Residential Development in Kilcock, Co
Kildare

Stage 1 Road Safety Audit

Document Ref:	P19-009-RP-001
----------------------	-----------------------

3.1 Problem

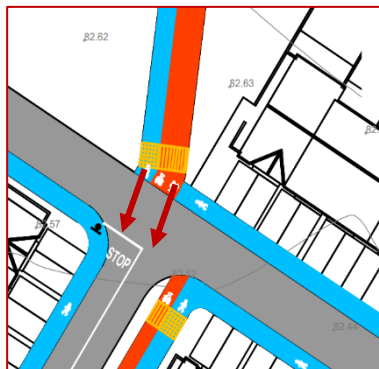
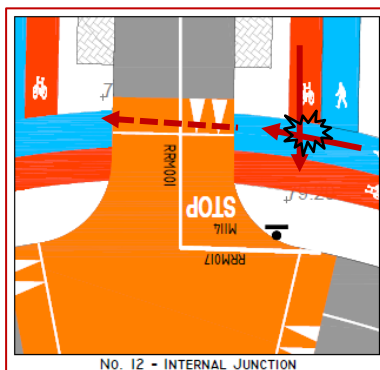
Summary: Long straight roads may lead to high speeds.

The proposed arrangement includes long straight sections within the development. This may encourage higher vehicle speeds within the development, leading to loss of control collisions or vehicle/pedestrian collisions.

Provide comprehensive traffic calming measures within the development.

3.2 Problem

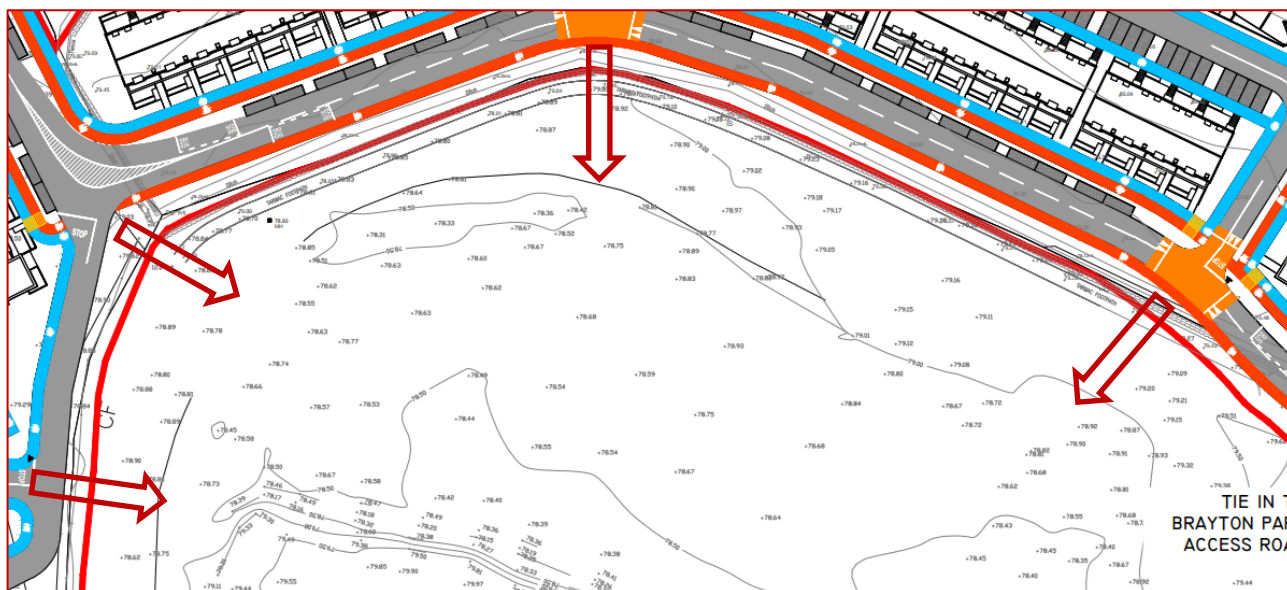
Summary: Pedestrian and Cyclist links not always clear, and sometimes direct VRUs into the middle of a junction.

Several footpath links do not appear to lead to a corresponding footway on the opposite side of the road. Upon entering the road or junction, mobility or visually impaired pedestrians may be unable to access the footway on the opposite side of the carriageway, and be forced to travel along the road edge until dropped kerb access is provided, which may increase the risk of being struck by a vehicle.

Also, Cycleway yield markings are not indicated where cyclist and pedestrians meet at junctions, or where cyclists enter the carriageway. Insufficient guidance for cyclists at the end of a designated cycleway may result in cyclists failing to yield to other road users, resulting in side-on collisions or pedestrian/cyclist collisions.

Additionally, pedestrian footways appear to coincide with the raised table 'ramp gradient', such that crossing pedestrians are either forced to walk on a sloped surface, or to enter the path of crossing cyclists. This could result in slips, trip and falls, or pedestrian/cycle collisions.

Ensure tactile paving, dropped kerbs, road markings and signage is used to support safe pedestrian and cyclist movement through the development.

Also, provide safe crossing points on pedestrian desire lines, and ensure visually and mobility impaired pedestrians can easily access the opposite side of the road at crossing points, and on a surface that is flat and level.

3.4 Problem

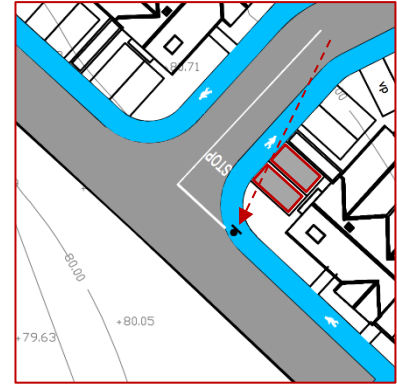
Summary: Unclear where public lighting columns will be located relative to the footpath.

At this early stage in the design process, information regarding proposed public lighting columns has not been provided to the Audit Team. It is assumed that public lighting columns will be provided throughout the proposed development. It is unclear, however, if these public lighting columns will be located within grass verges or within the footpath. Should public lighting columns be located within the footpath the effective width of the footpath will be reduced resulting in pedestrians having to enter the carriageway to avoid the obstruction leading to an increased risk of collisions with vehicles and cyclists.

Ensure public lighting columns are located at the back of the footpath or within the grass verge such that they do not constitute a hazard to pedestrians and vehicles.

3.6 Problem

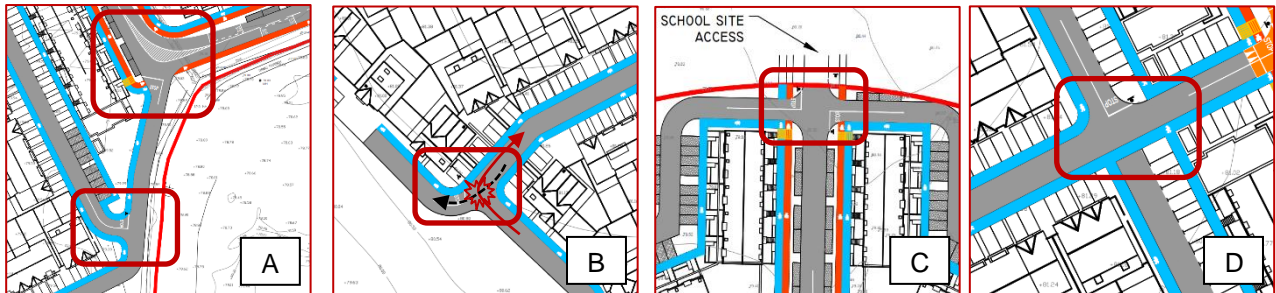
Summary: Junction layout strategy may lead to unsafe vehicle/VRU manoeuvres

Junction form and arrangement varies across the residential development, and may lead to driver confusion, unsafe vehicle manoeuvres, high entry/exit speeds and VRU confusion. The following examples have been identified.

- A. Junctions located at high demand bends may lead to a wide junction mouth that encourages high vehicle entry and exit speeds, particularly where visibility is limited. This could lead to overshoot or side-on collisions where drivers fail to reduce their speed on approach to the junction, or enter the junction without due care and attention.

Additionally, right turn vehicles on the main spine road will likely wait in the hatched area before completing their turning movement, which may lead to side-swipe collisions with buses travelling in the opposite direction (swept path analysis drawing confirms buses traverse hatch area).

- B. It is not clear if this junction is required, as it does not appear to serve any plot access or parking provision. The location of the junction could promote side-on collisions where right turning vehicles move across the path of a vehicle continuing right around the high demand bend.

- C. Crossroad junctions should be avoided where possible, as drivers approaching the Stop line may be unable to discern the crossing road at the junction, leading to vehicles entering the crossing road without slowing/stopping. This could result in overshoot incidents and side-on collisions with vehicles travelling on the major road. This problem may be exacerbated by the nearby school, which may experience high traffic volumes, informal parking and increased pedestrian/cyclist volumes.

- D. It is not clear if this is a cross road junction, or if the proposed footway is designed to create a Cul-de-sac arrangement.

- Crossroad junction: As above, priority control Crossroad junctions should be avoided, as drivers approaching the Stop line may be unable to discern the crossing road at the junction,

leading to vehicles entering the crossing road without slowing/stopping. This could result in overshoot incidents and side-on collisions with vehicles travelling on the major road.

- **Cul-de-Sac:** If a Cul-de-sac arrangement is proposed, it is not clear how large vehicles will perform a 180° turn. If HGV drivers are unable to turn their vehicle, they may be forced to reverse along the road where there is an increased risk of a rear-end-shunt, vehicle/pedestrian, vehicle/cyclist or material damage collision. HGV drivers may also attempt to mount the footway to gain access to the carriageway on the other side of the closure, leading to vehicle/pedestrian and side-on collisions.

A high-level review should be undertaken to identify junction forms and arrangements which are more consistent with DMURS, and better mitigate the problems identified above.

Additionally, the designer should determine if the number of junctions proposed is required, and seek opportunities to simplify the number of junctions within the development.

3.12 Problem

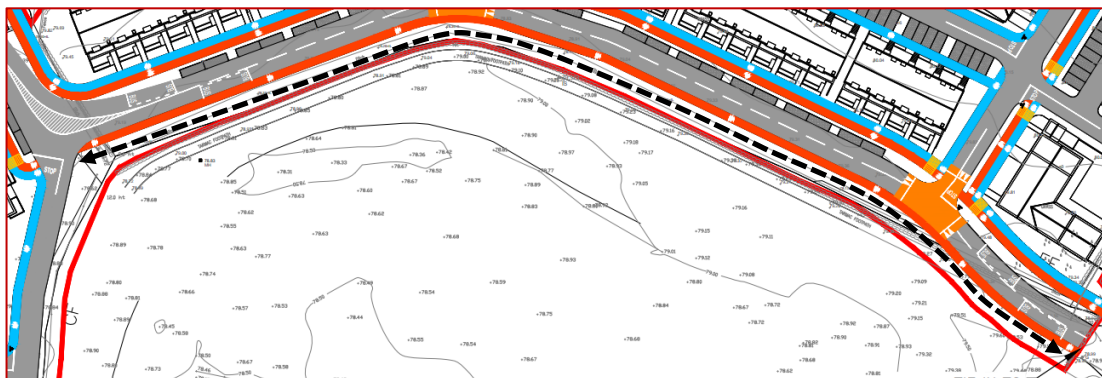
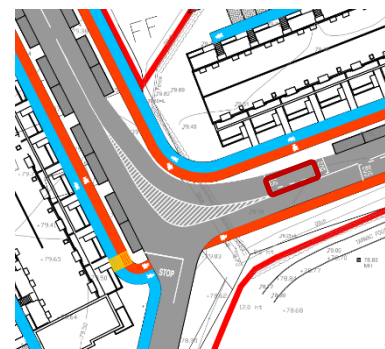
Summary: Pedestrian footway missing between entrance and high demand bend.

A pedestrian footway has not been provided between the development's entrance and the westbound bus stop located on the spine road. This route will serve as an important pedestrian route through the development, and for pedestrians wishing to access the playing fields and walking paths. It will also accommodate residents wishing to use the bus stop currently proposed.

Failure to provide a footway may lead to an informal path being created, which could lead to slips, trips and falls. It may also encourage pedestrians to use the cycle track, where there is an increased risk of being struck by a cyclist, or forcing cyclists to use the carriageway where there is an increased risk of being struck by a vehicle.

Provide a footpath along the southern side of the main road.

Appendix D – Problem Locations

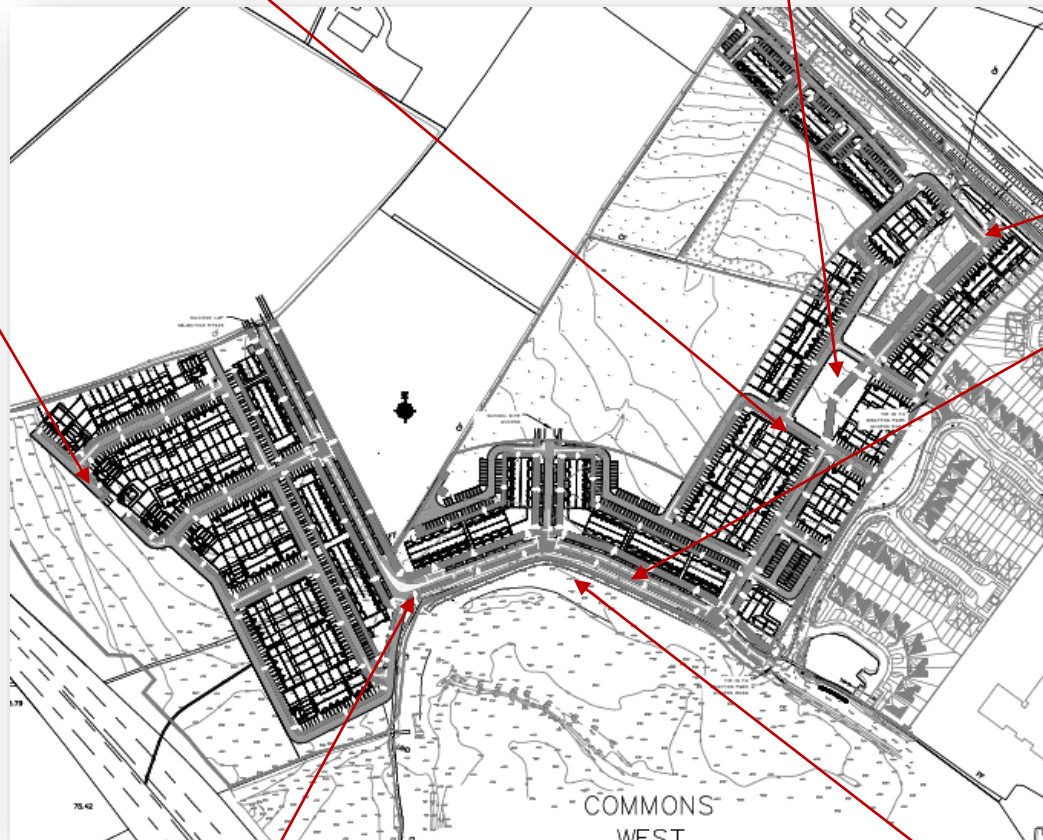
General Problem 3.1: Long straight roads may lead to high speeds.

General Problem 3.4: Unclear where public lighting columns will be located relative to the footpath.

Problem 3.5: Insufficient visibility to Stop signs

General Problem 3.6: Junction layouts may lead to driver and VRU confusion, high entry/exit speeds and possible sight through issues

General Problem 3.8: Pedestrian crossing points not clearly identified within the proposal

General Problem 3.9: Tactile paving details do not include in-line tactile paving arrangements

Problem 3.2: Pedestrian and Cyclist links not always clear, and sometimes direct VRUs into the middle of a junction.

Problem 3.7: Locating cycle/pedestrian track through the middle of an open public space may lead to young children playing on the segregated track.

General Problem 3.10: Sections indicate parking on raised footway

General Problem 3.11: Sign proposed on the cycle track

Problem 3.7: Pedestrian footway missing between entrance and high demand bend.

Problem 3.13: Bus stop provided directly after high demand bend.

Problem 3.3: Unclear if there is sufficient interconnectivity between the proposed development and proposed playing pitches to the south.
